BOARD OF ZONING APPEALS DIVISION I

January 7, 2025

Case Number: 2024-DV1-037 (Amended)
Address: 2402 East 38th Street (approximate address)
Location: Washington Township, Council District #8
Zoning: C-5 (TOD) (W-5)
Petitioner: Popeyes Louisiana Kitchen Inc., by Gilligan Company
Request: Variance of Use and Development Standards of the Consolidated Zoning and Subdivision Ordinance to provide for a drive-thru accessory use within 600 feet of a Transit Station (not permitted), and an additional drive-thru lane within the front yard of Keystone Avenue (not permitted).

Site Plan

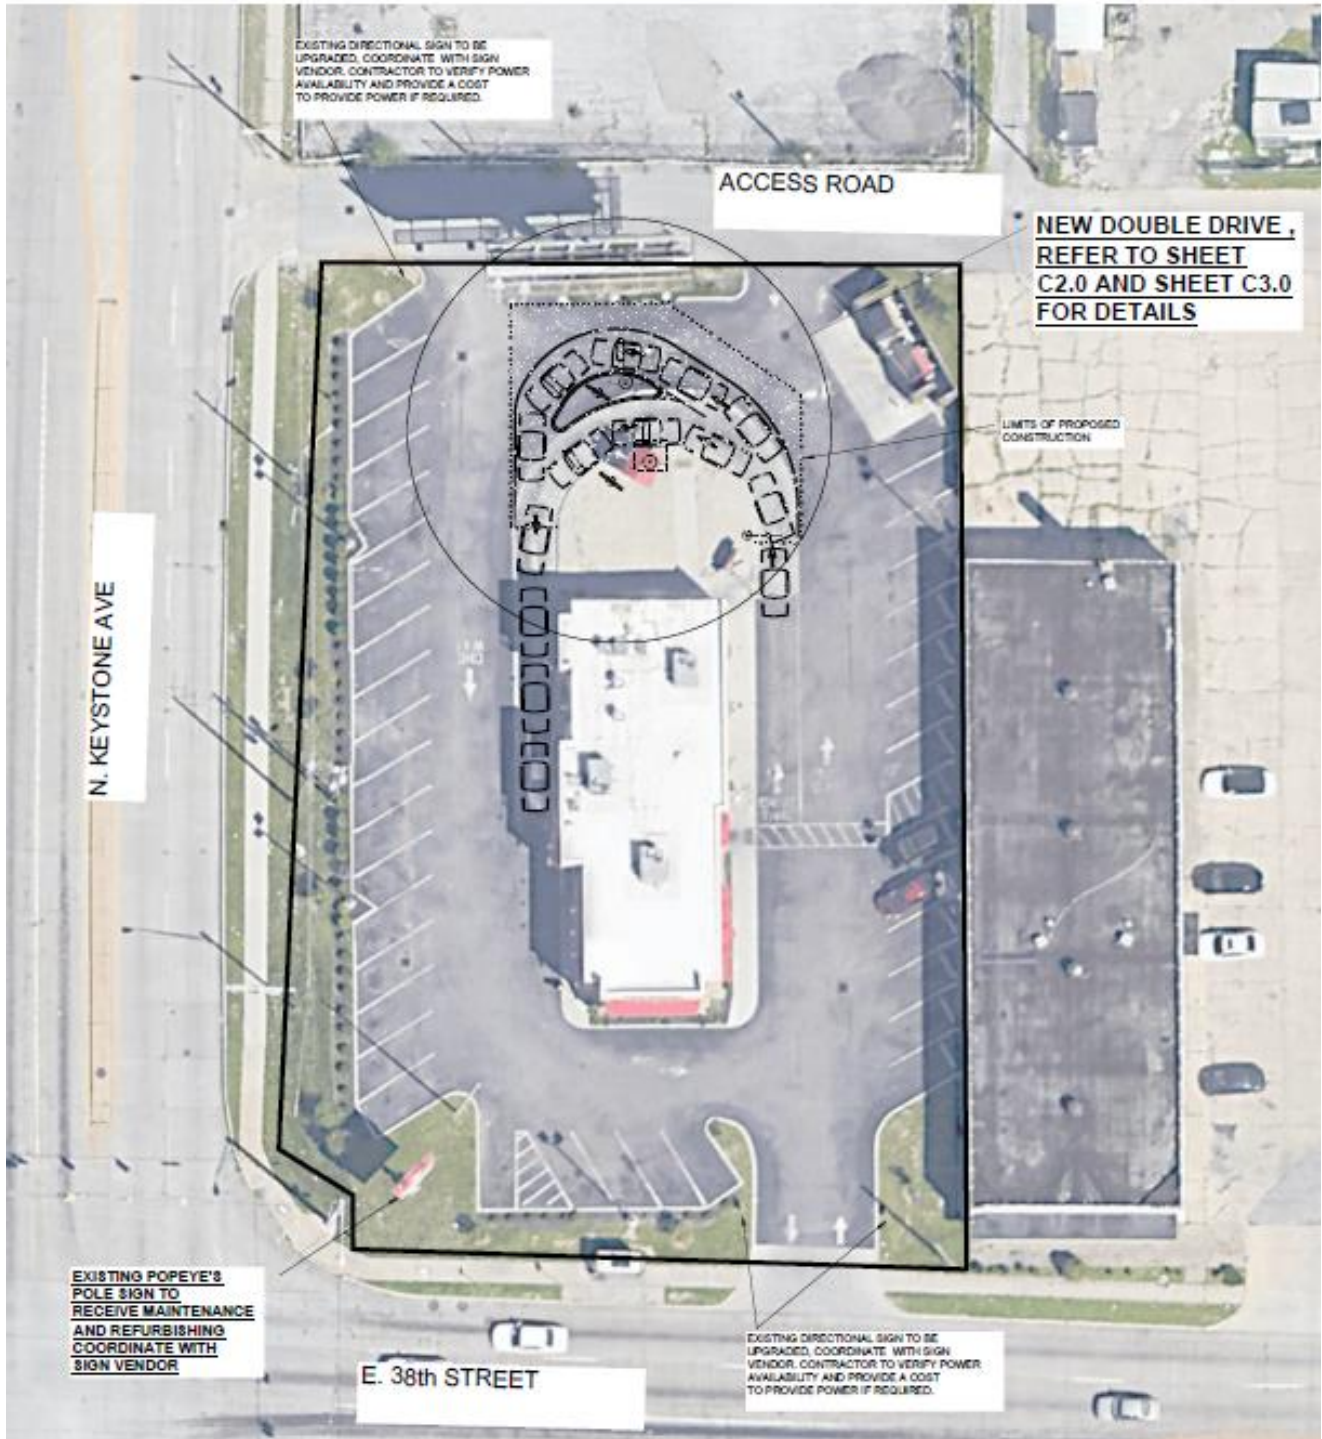
- ◇ In 2024, permit applications were made to allow for an interior and exterior remodeling of the property. These plans included a partial addition to the drive-thru lane (see site plan below). This reconfiguration of the site would require the full drive-thru lane to comply with current ordinance standards for stacking spaces within front yards, and for the primary entry transparencies to be compliant as well.

- ◇ Current ordinance standards prohibit stacking spaces within front yards along rights-of-way greater than 30 feet wide, and would require exclusive bypass aisles, as well as the compliance with the screening requirements per 743-306.I.3. The grant of this variance request would allow for an additional drive-thru lane and legalize the non-conforming existing drive-thru lane within the front yard of Keystone Avenue and expand it further.

- ◇ Limitations on the placement of stacking spaces within front yards exist to reduce congestion and vehicular conflict with patrons of the restaurant and pedestrians as well as to allow for attractive, pedestrian-oriented storefronts facing rights-of-way (screening requirements also contribute to these goals).

- ◇ As this site lies within the Transit Oriented Development (TOD) Overlay for the Bus Rapid Transit (BRT) Purple Line, proposed uses, and the redevelopment of existing uses as for this property, should be oriented towards supporting the Overlay district design and establishing greater walkability in the district. The proposed request for the additional drive-thru lane within the front yard of Keystone Avenue would expand a non-compliant auto-centric use that is non-contributing in the Overlay which would be counterproductive to the intent of establishing greater walkability and connectivity in the area, therefore Staff does recommend denial of this request.
